651S-1
GENERAL PURPOSE HF RECEIVER

PUB NO.	NOTE	DATE	SUBJECT
IB 1-72 ✓		03/01/72	Subassembly Interchangeability
SB 1		10/01/72	Reduction of 450-kHz Leakage From Synthesizer Reference Board All
SB 2		06/06/73	Reduction of Noise Level
SB 3		07/15/73	Add Keep-Alive Frequency Memory Function
SB 4		07/15/73	Extend Comma and Decimal Lamp Life in Frequency Display
SB A ✓		11/01/73	Change DCFE Filter Switching Diode
SB 5	1	12/15/74	Minimize TCU Circuit Card Response to Data Link Noise and Failure
SB 6	2	03/01/75	Reduce Intermodulation Level
SB 7		02/07/75	Reduce Internal Spurious Signals
SB 8		12/27/74	Allow Remote Control Operation With RS-232C Serial Control Interface Card A9
SB 9 ✓		02/15/75	Increase Life of Display Tubes
SB 10 ✓	2	12/31/75 Revised 08/02/76, 04/01/77	Replacing Display Tubes With LED Plug-in Assemblies
SB 11		Not issued	
SB B ✓		11/15/74	KAV
SB C ✓		01/15/78	Supply KAV Power to DCFE
SB 12 ✓		05/01/78 Revised 07/01/78	Replacing Nonprocurable Integrated Circuits

SERVICE BULLETIN A

SUBJECT: Change DCFE Filter Switching Diode

P/O RF Mixer (618-3258-002)
Figure 2 (Sheet 1 of 2)

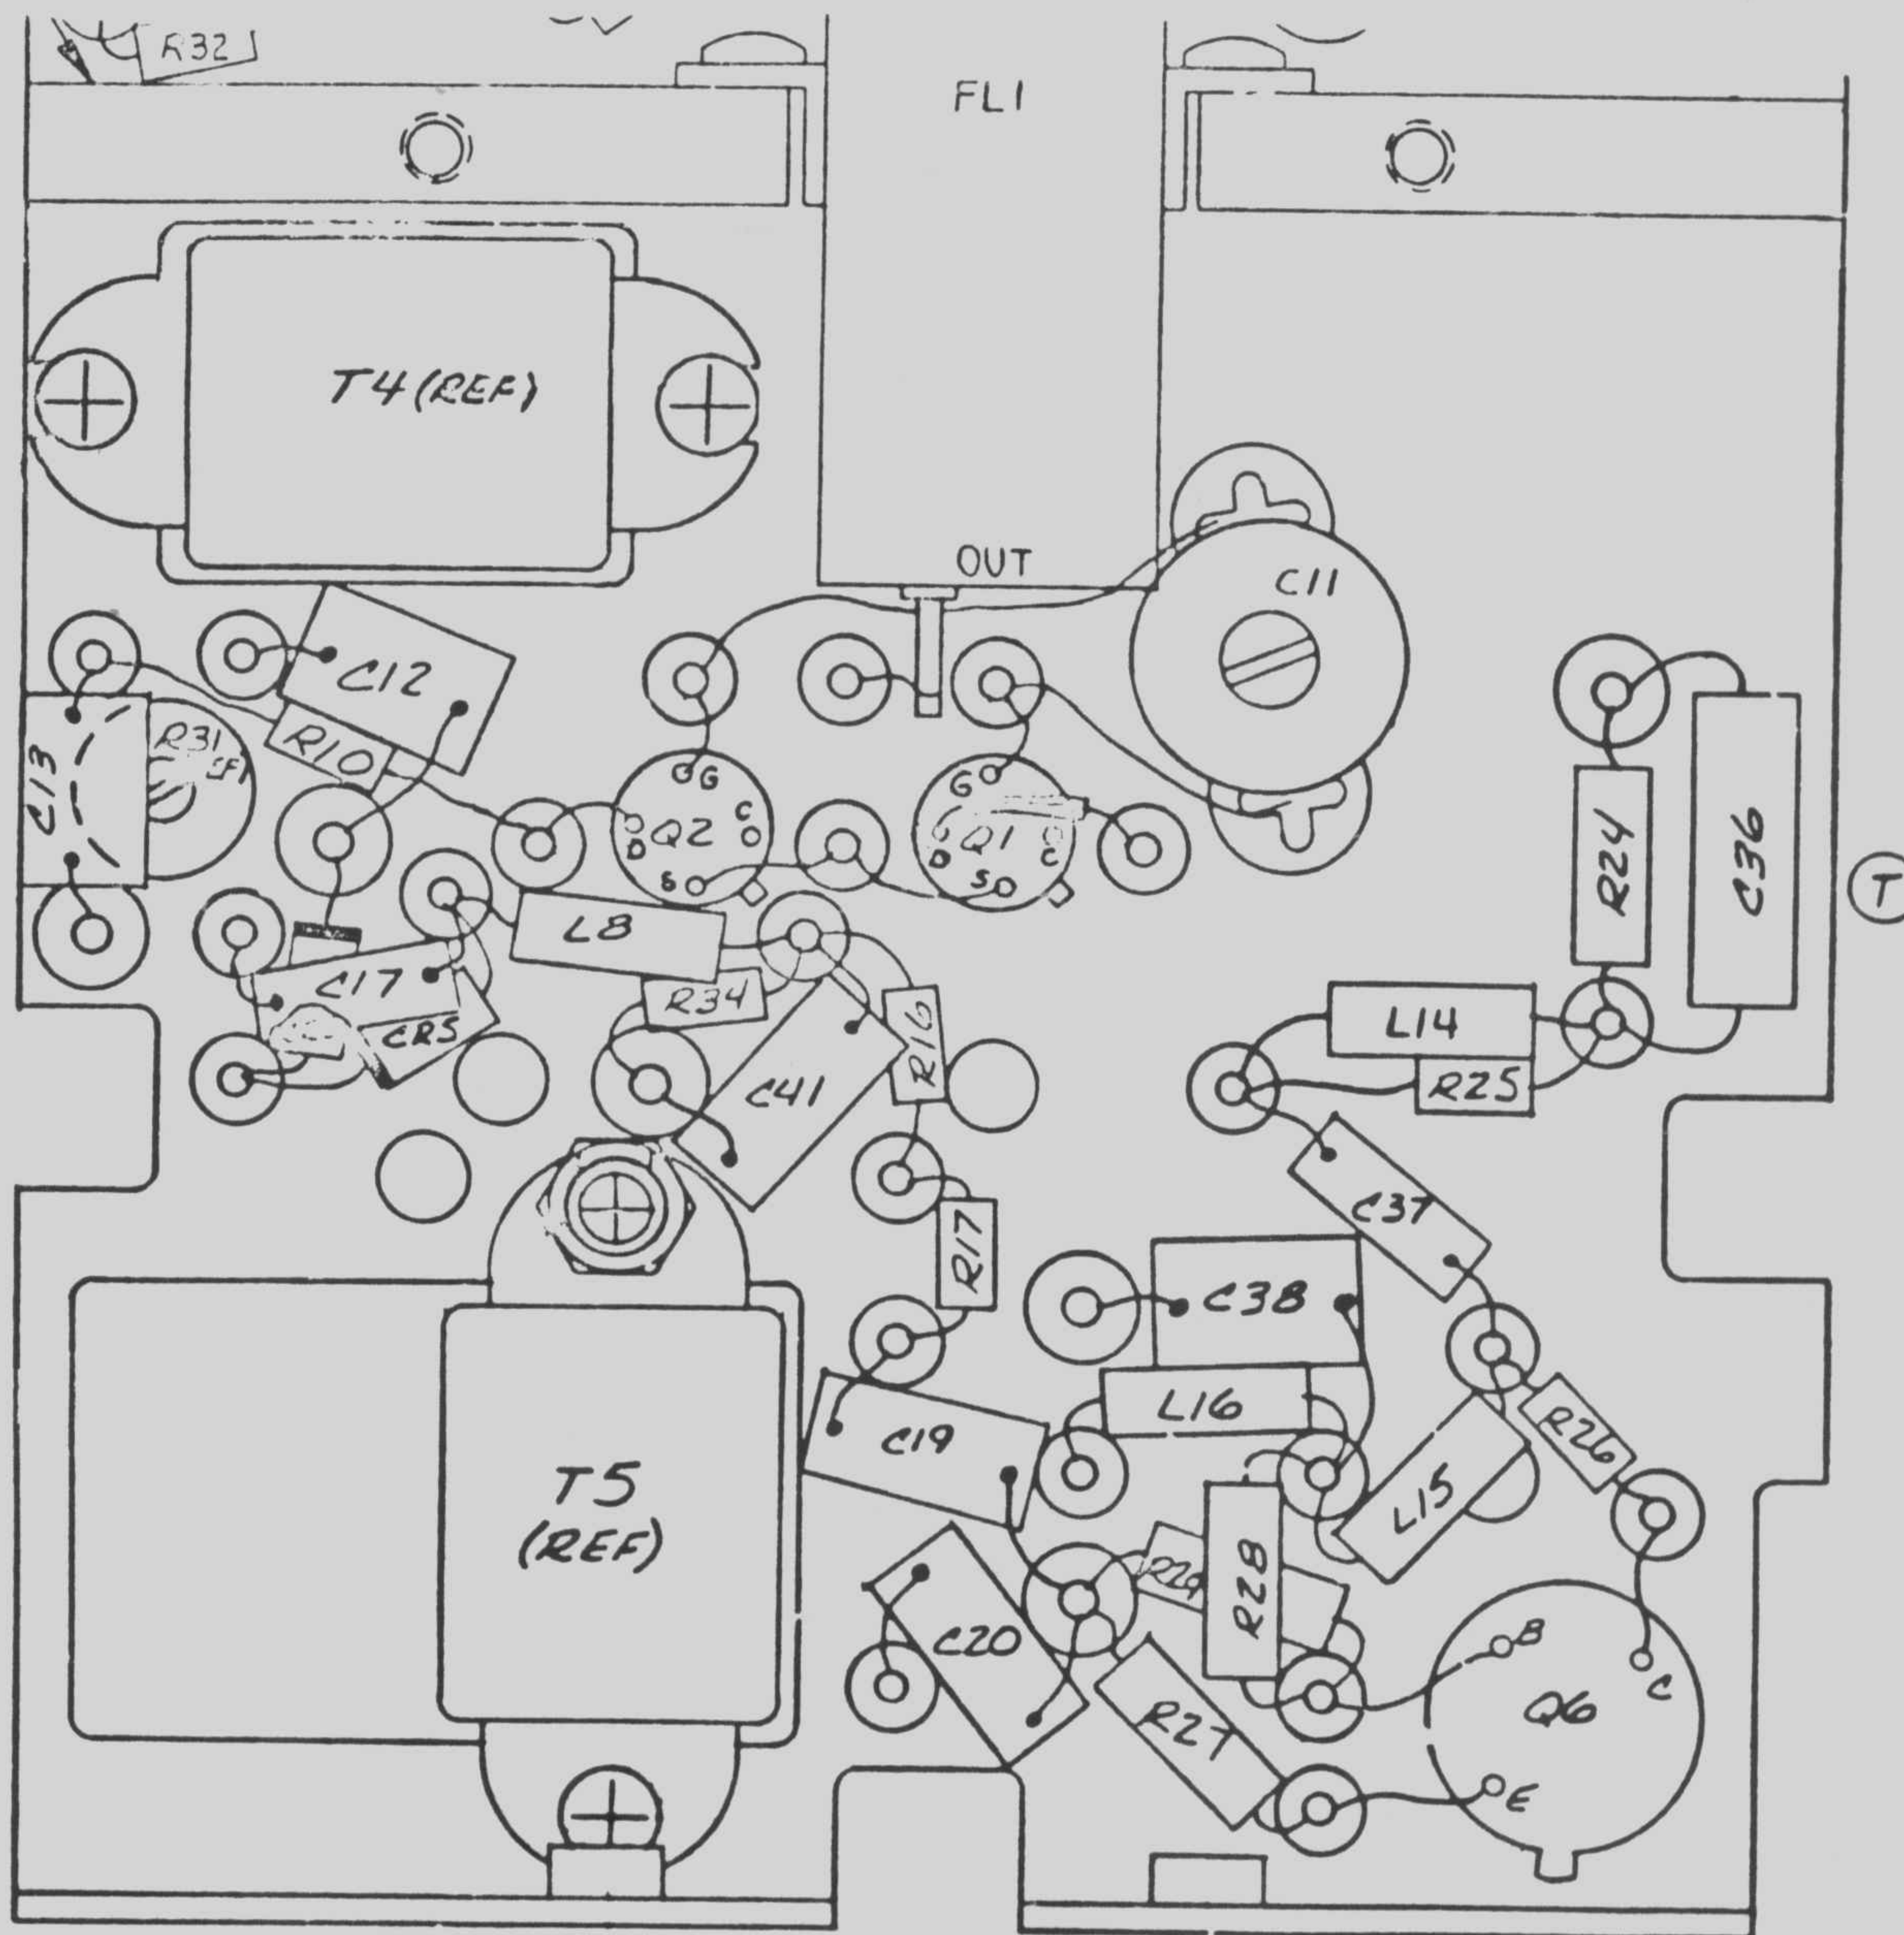
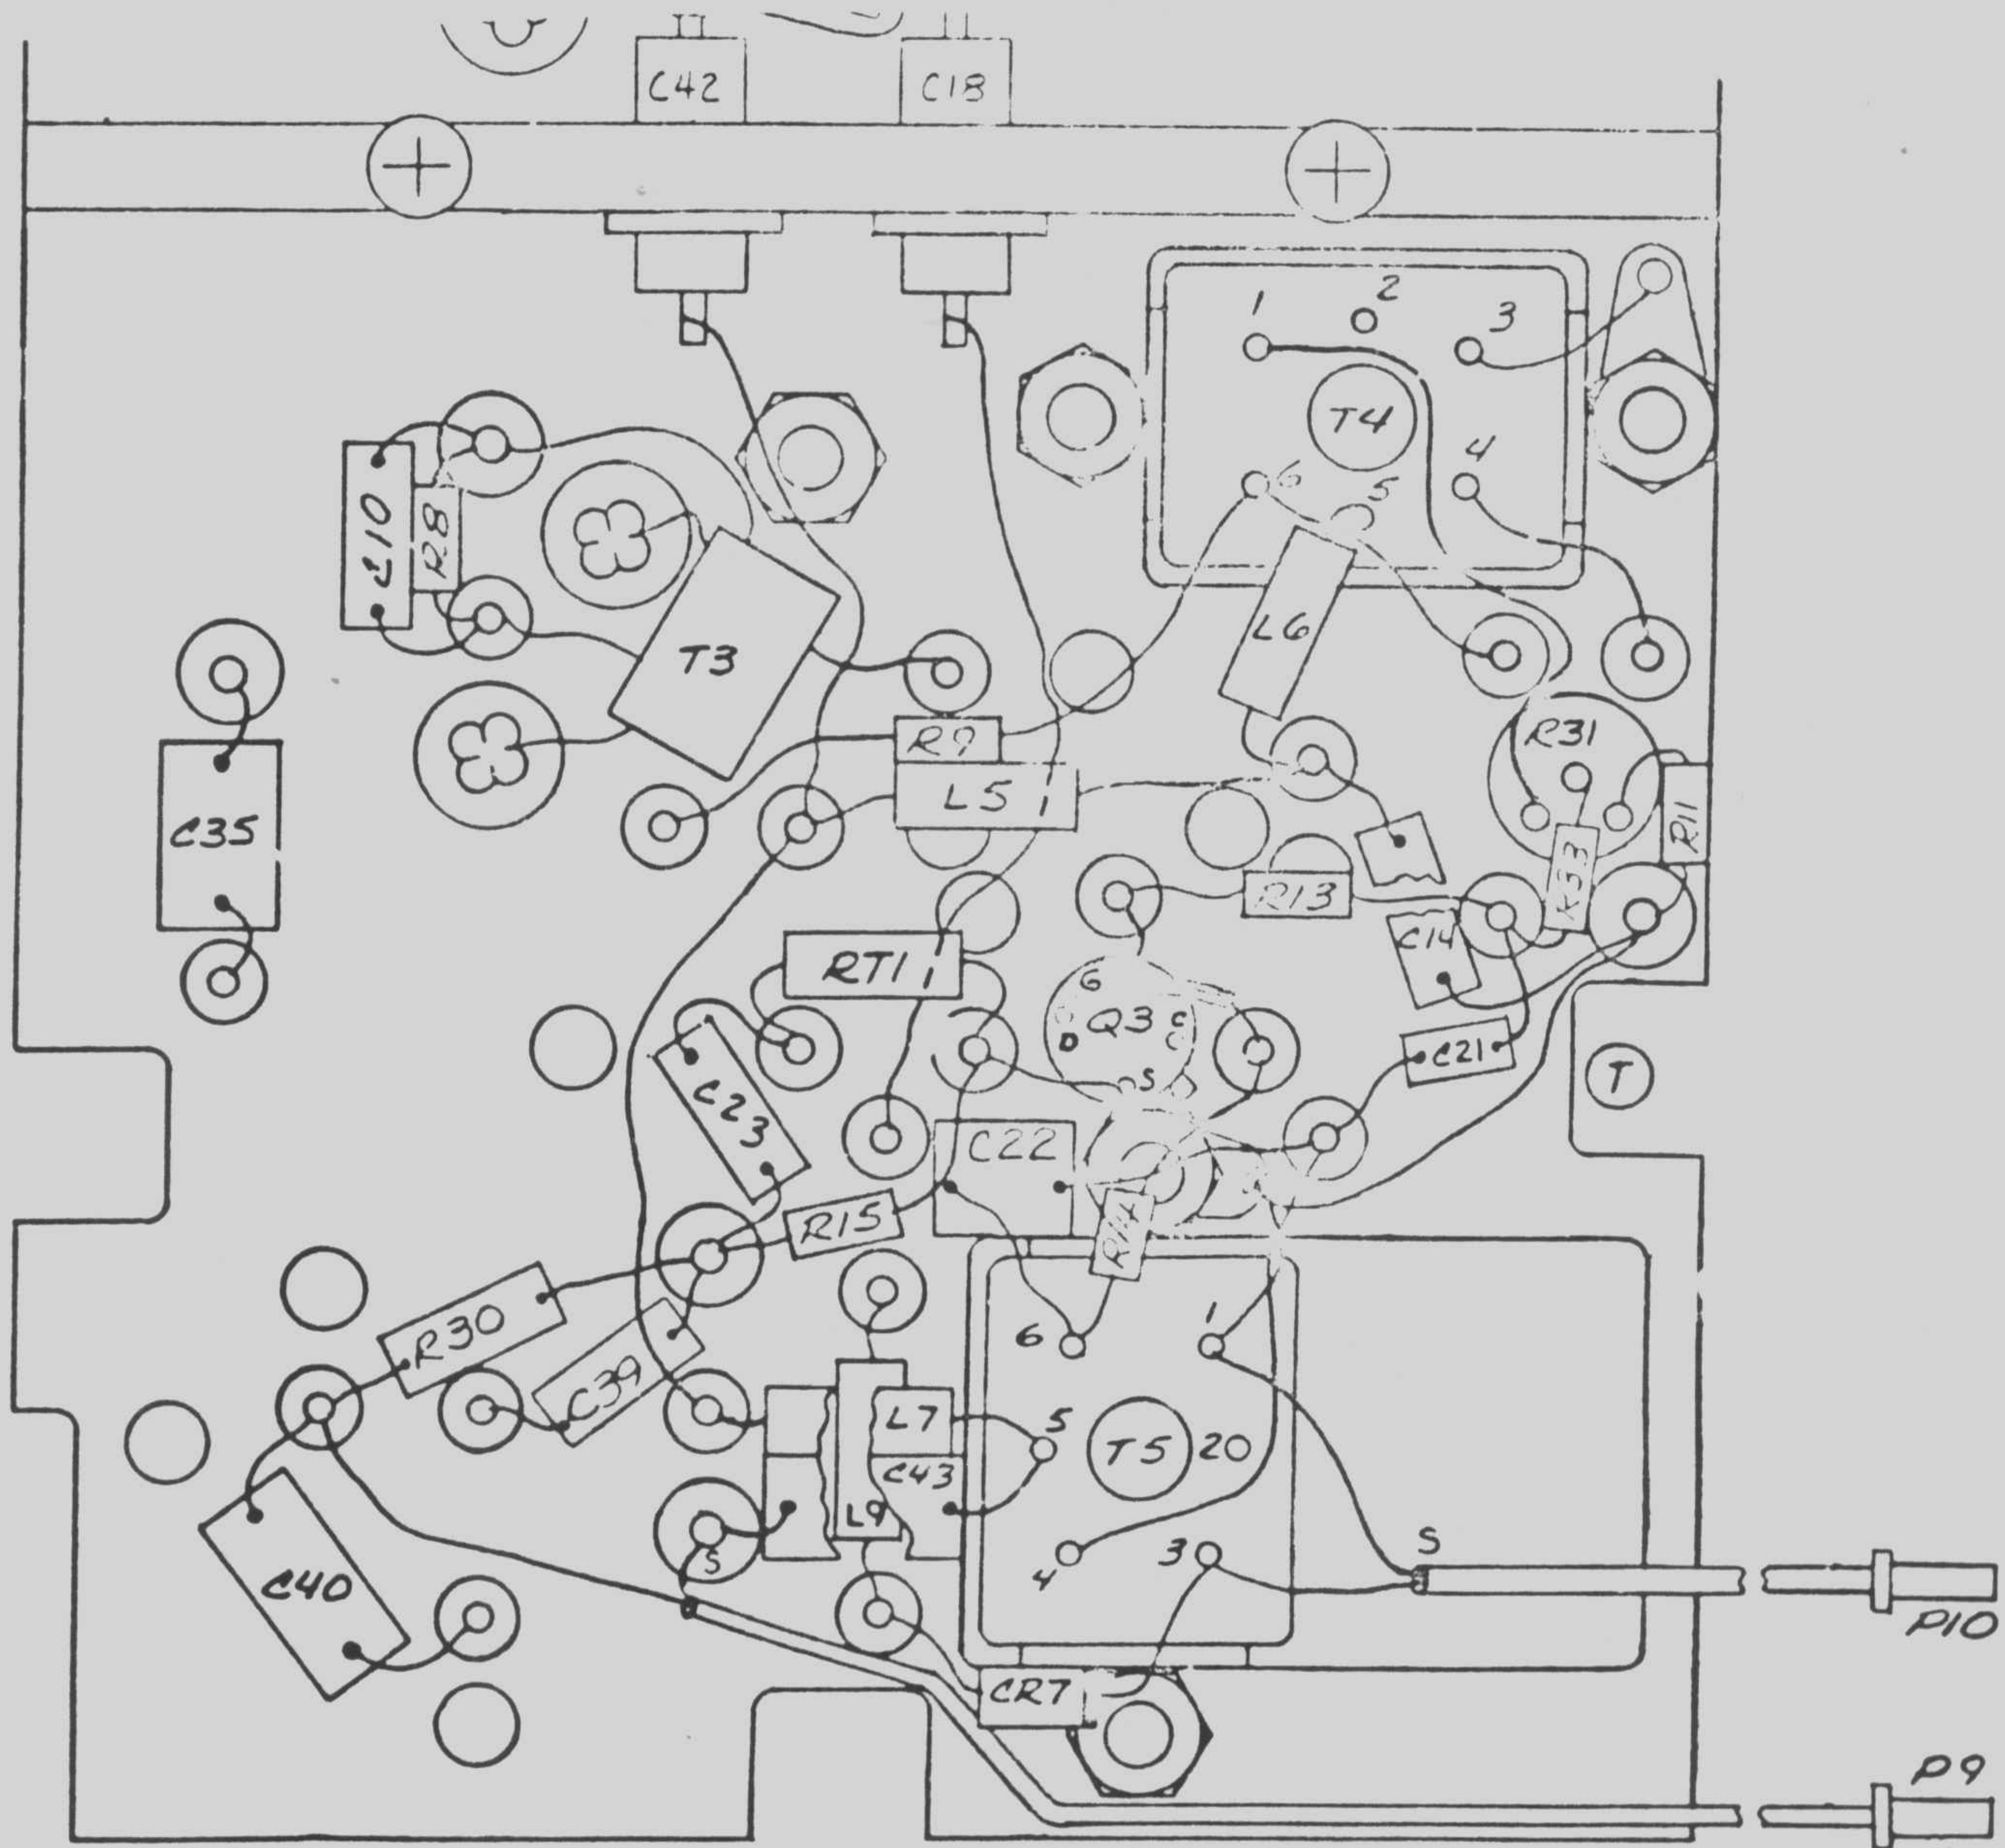
- H. Remove rf mixer cover (36-1).
- I. Remove transistors Q1 (37-17), Q2 (37-48), and Q3 (37-117).
- NOTE: Refer to figure 2 of this bulletin while performing steps J through L.

- J. Clip the case leads of the new transistors (352-0756-150) to a maximum length of 1.58 mm (1/16 in).
- K. Install the transistors upside down on the chassis using adhesive (005-1688-001). Q1 and Q2 must have the same vendor symbol for testing qualifications. Use insulation sleeving (152-2473-000) on the drain leads of Q1 and Q3.

- L. Connect the new transistors as shown in figure 2.
- NOTE: Refer to figure 3 of this bulletin and the 651S-1/1A instruction book parts list while performing steps M through P. Refer to figure 4 for a schematic diagram which includes these changes.
